City of Richmond Department of Planning & Development Review

PROPOSAL: Final Review of Warwick

Road Maintenance Facility

Warwick Road Maintenance Facility Improvements – UDC Narrative

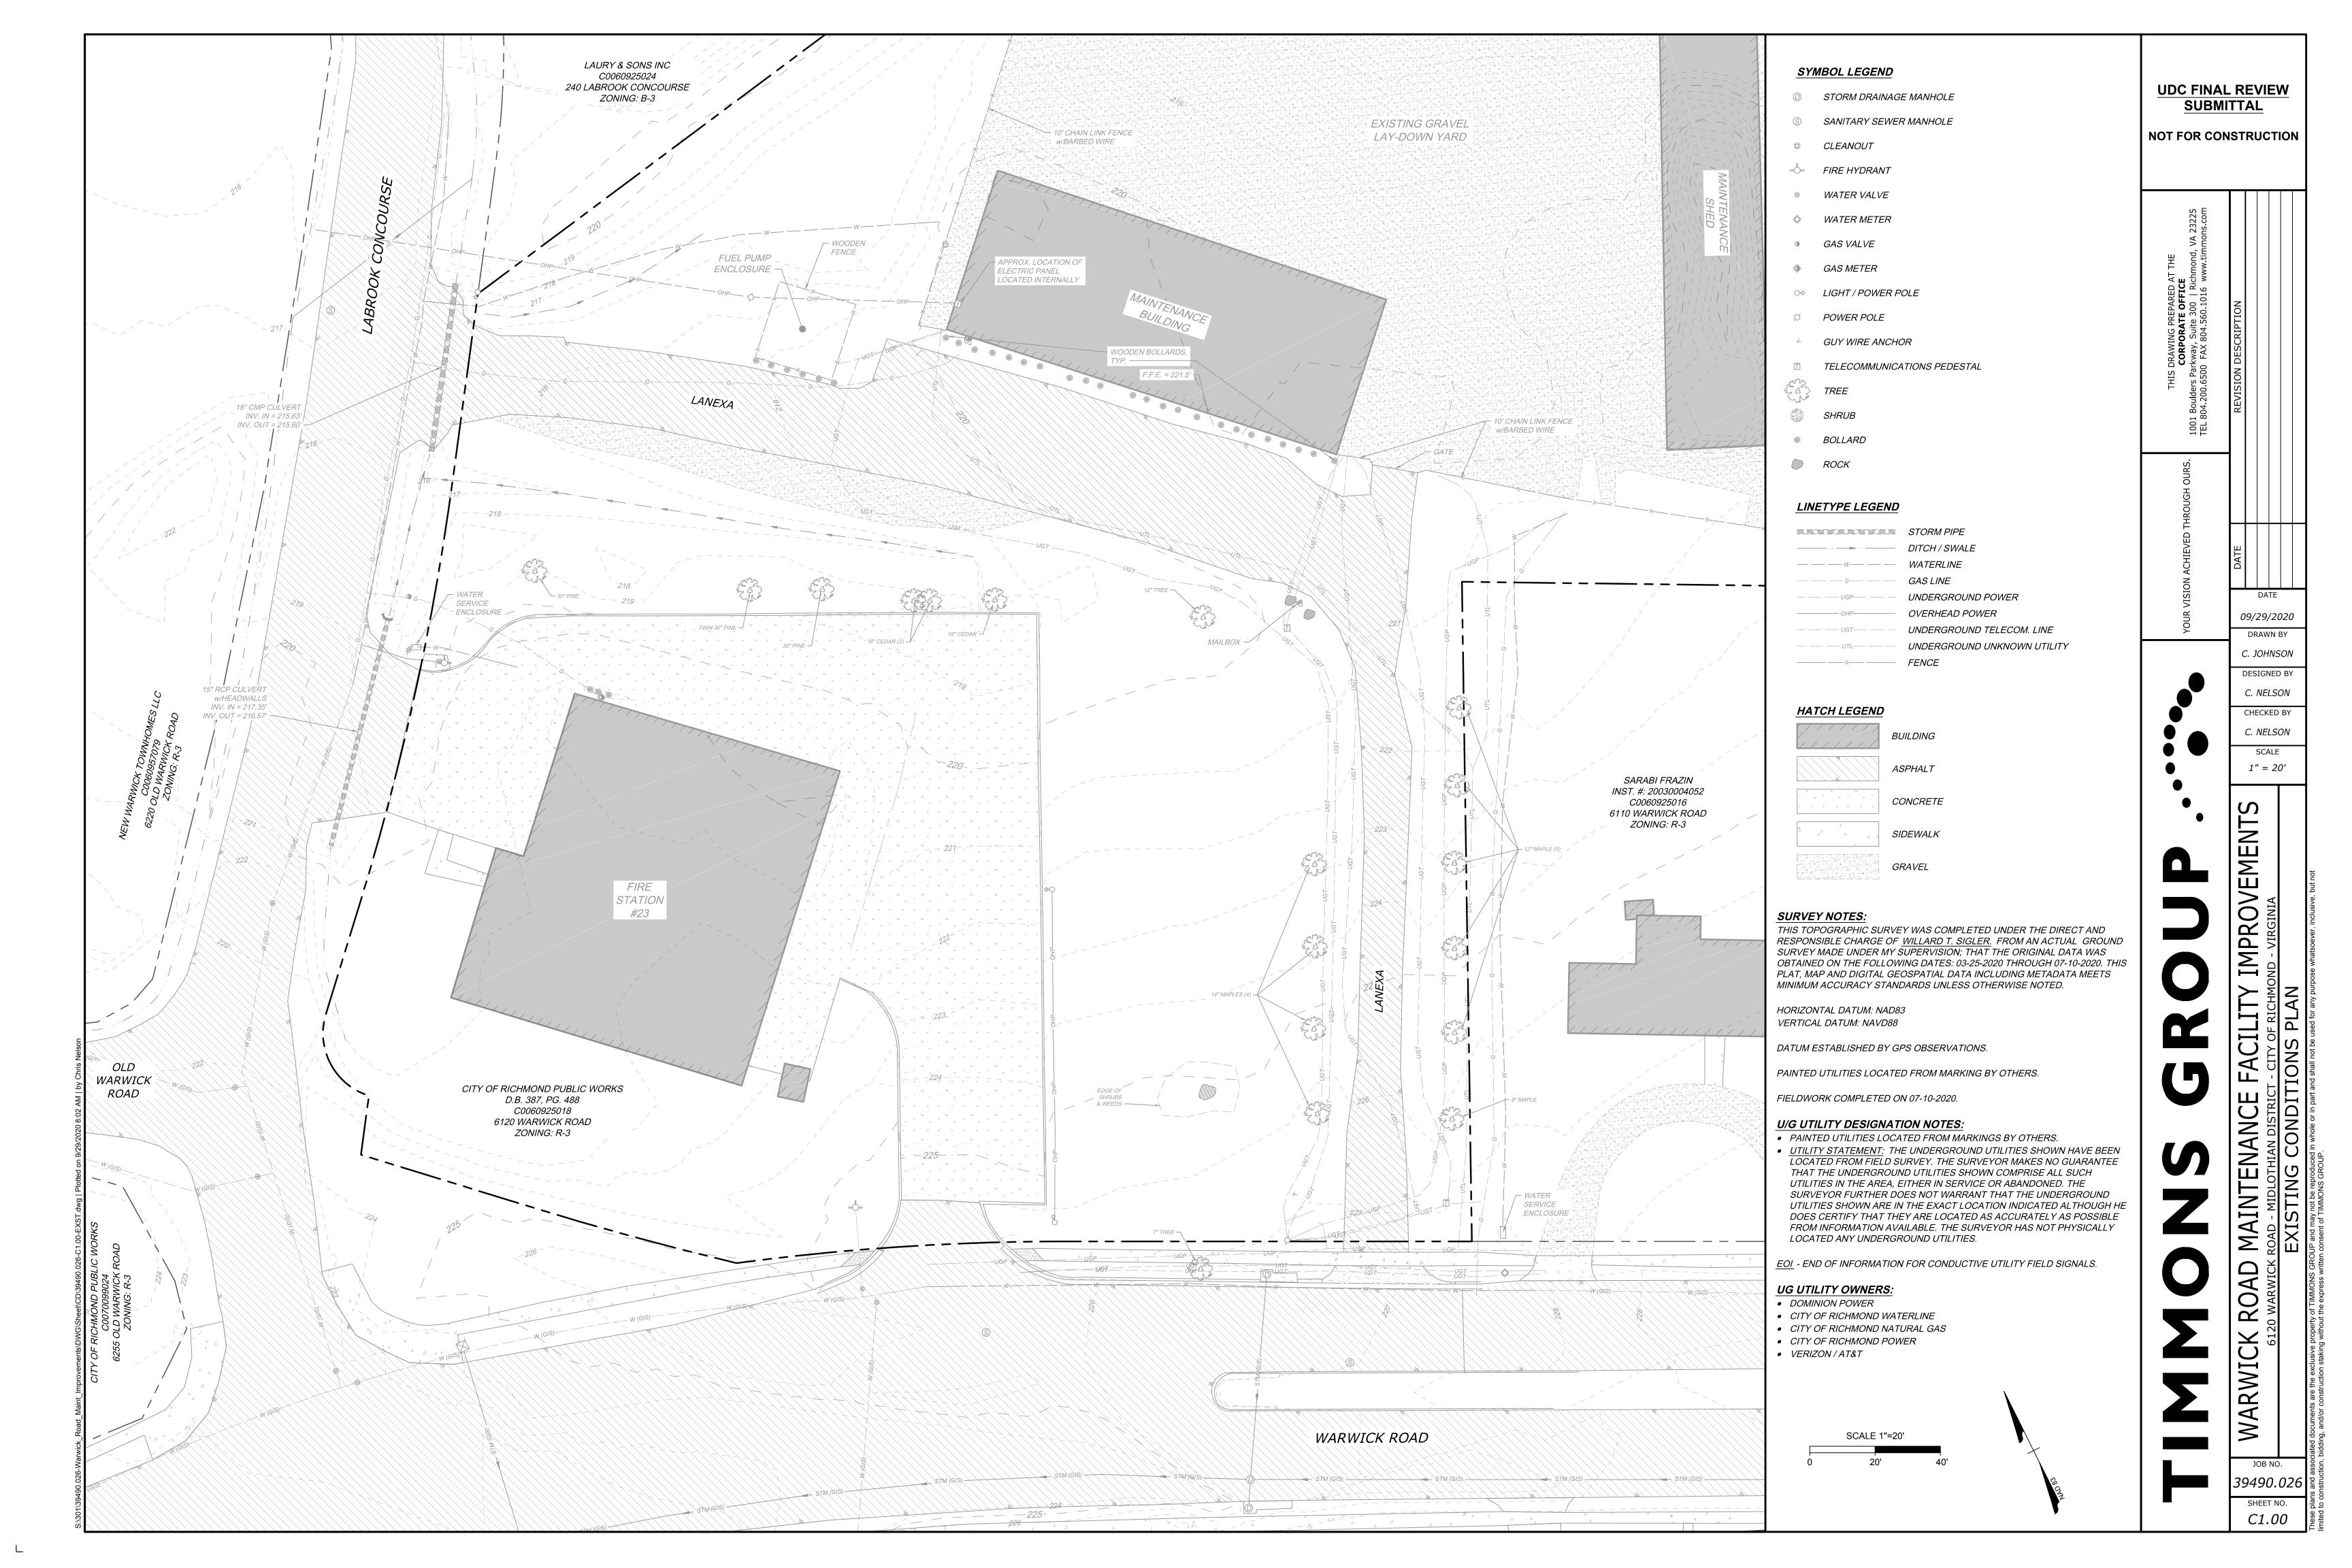
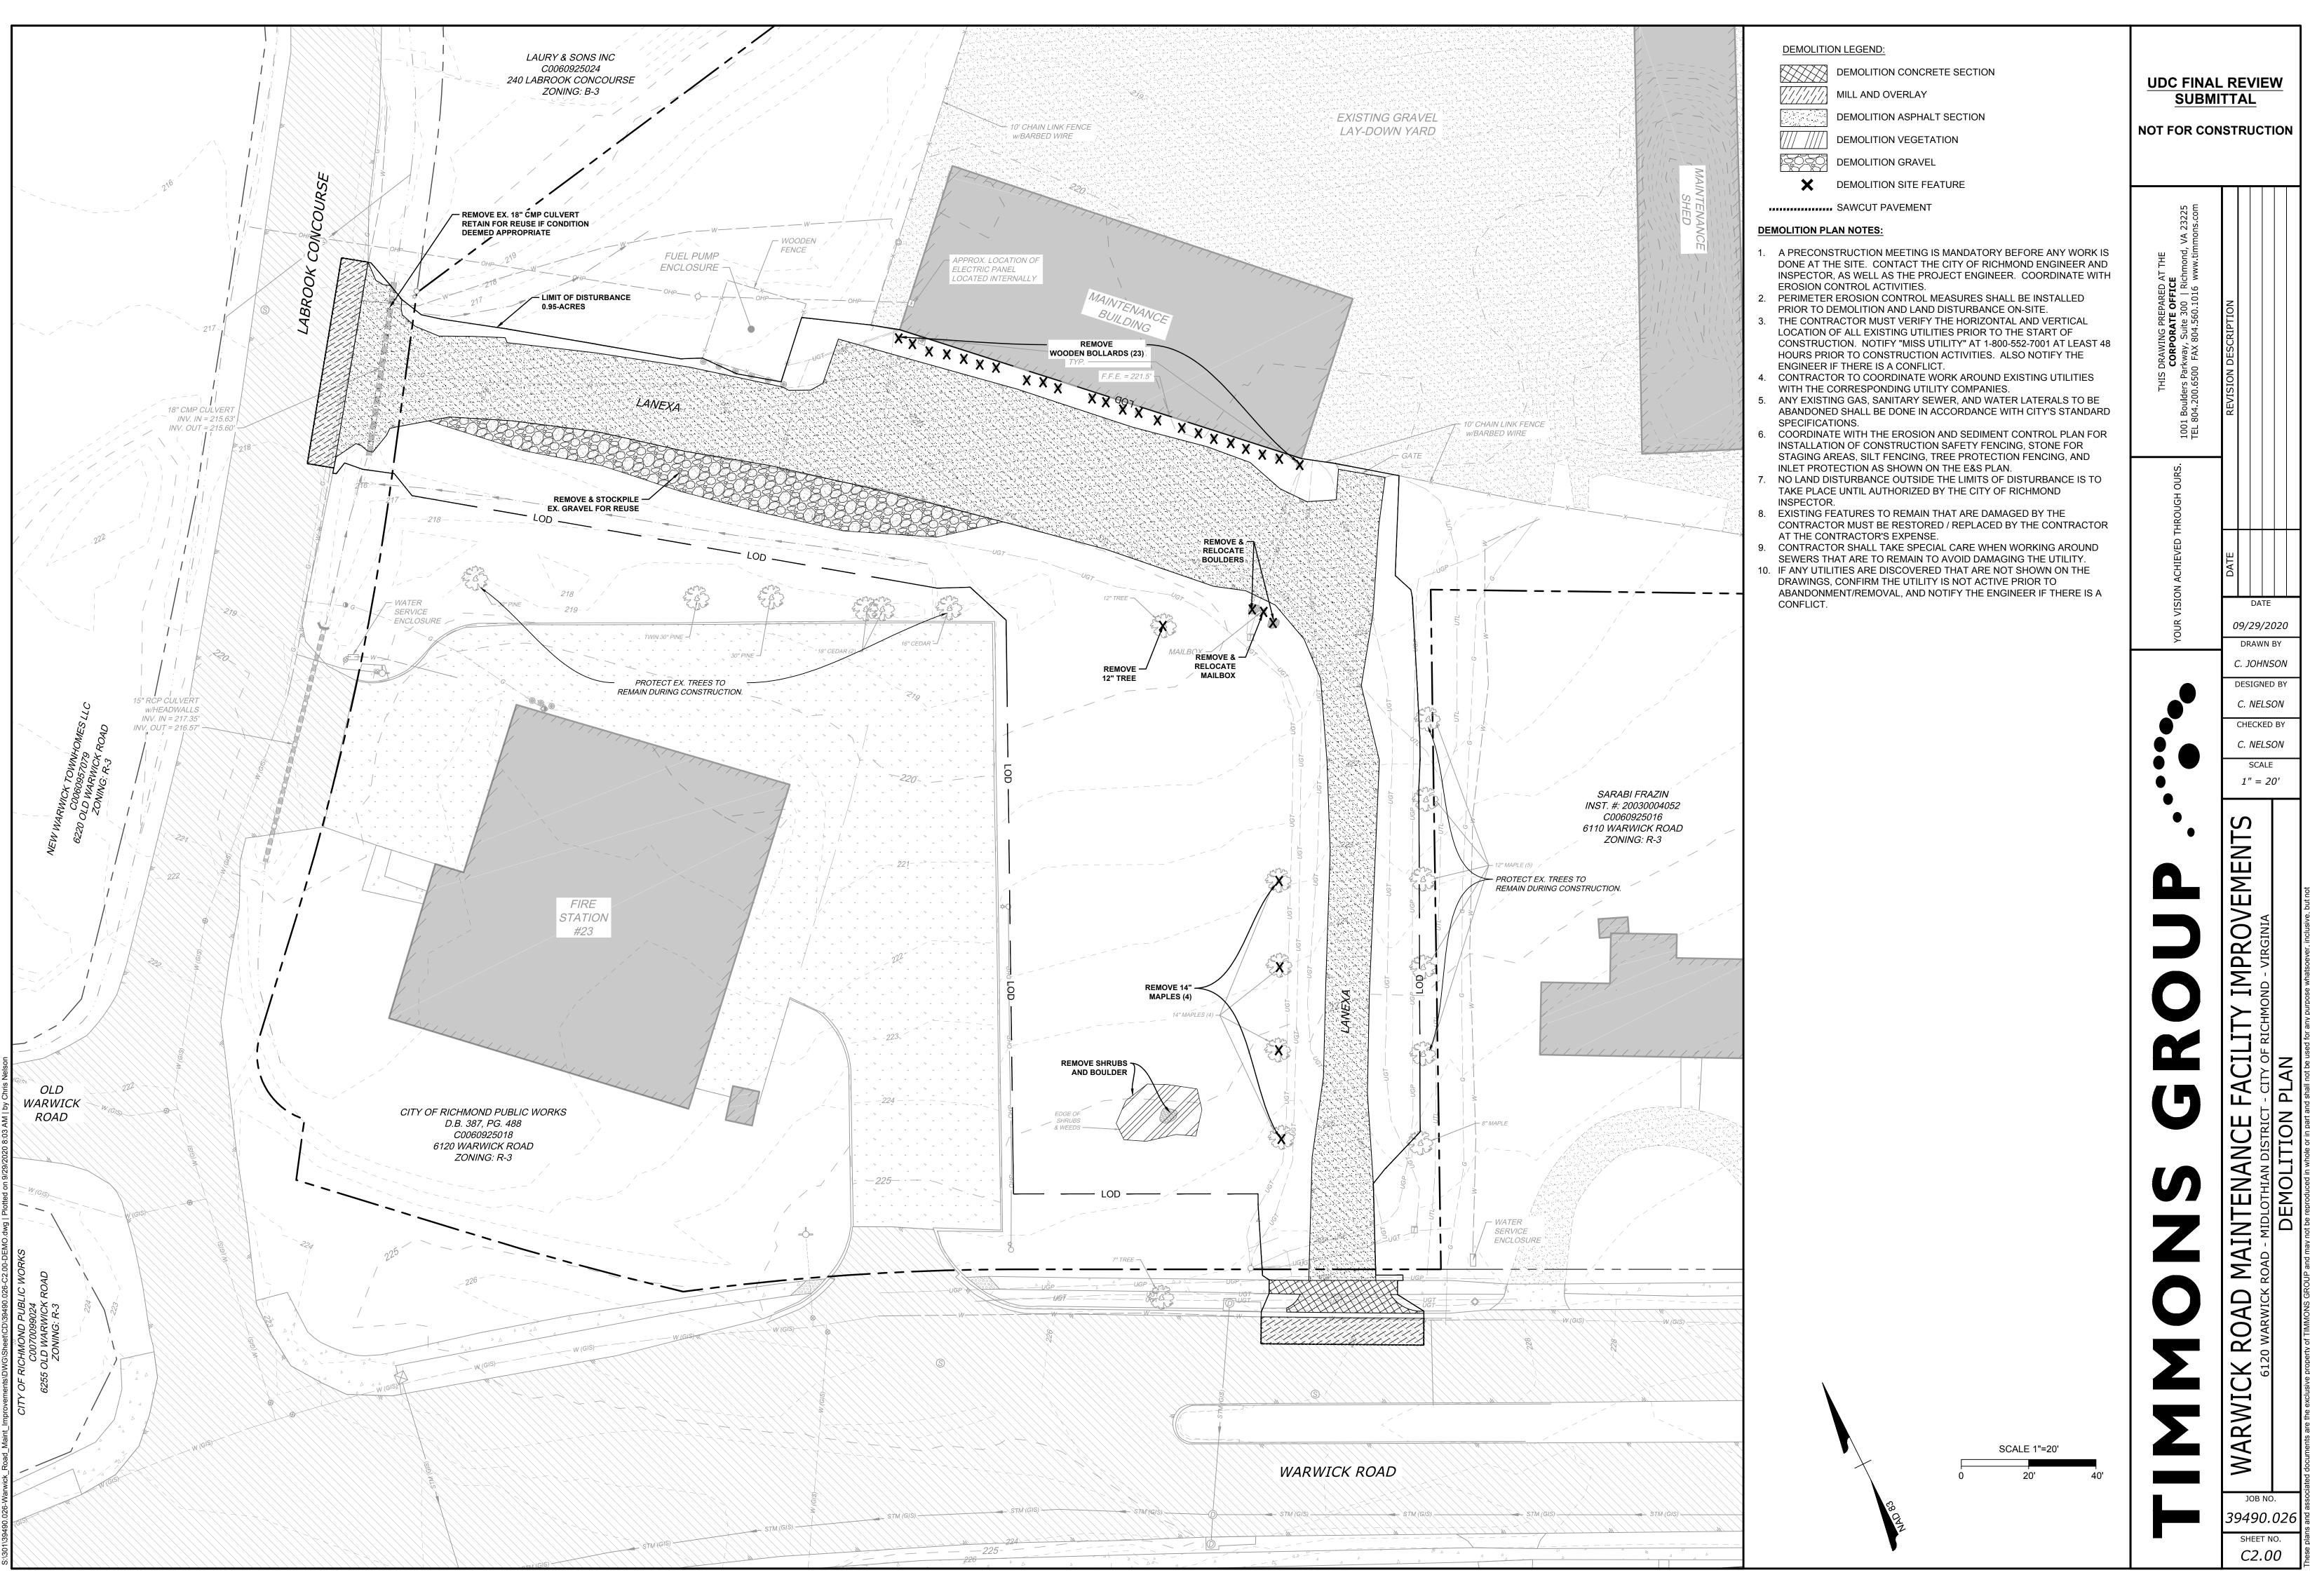
- Applicant consider pervious paving materials for the parking spaces in front of the maintenance building.
 - √ TrueGrid permeable pavement is now being proposed in 3 specific areas of the site: laydown yard, angled parking spaces to the east, and the parking spaces closest to the fire station parking lot.

- The new fencing installed as screening around the new lay-down yard be wooden and stained a neutral color.
 - ✓ Due to the nature of the proposed use within the laydown yard, and in an effort to keep overall project costs down, a more secure and cheaper fence type will be used. The project is proposing to use black vinyl coated chainlink fence.

- Larger shade trees proposed in the landscape plan be prioritized on the west and south side of the new lay-down yard to further enhance screening from Warwick Road.

- ✓ The top of the TrueGrid permeable pavement is installed with a rigid system to enhance stabilization of aggregate fill material.
- Applicant consider the feasibility of locating the new canopy structure to the northeastern portion of the lay-down yard, away from Warwick Road, so that it may be less visible from the main road.

- √ This recommendation was adhered to and is reflected in our current landscape plan.
- For gravel parking spaces, if grade allows, applicant consider setting first layer of gravel in a stabilizing grid to further protect the gravel from being washed away.

- ✓ The proposed canopy structure has been relocated within the laydown yard in an effort to reduce its visibility from Warwick Road.
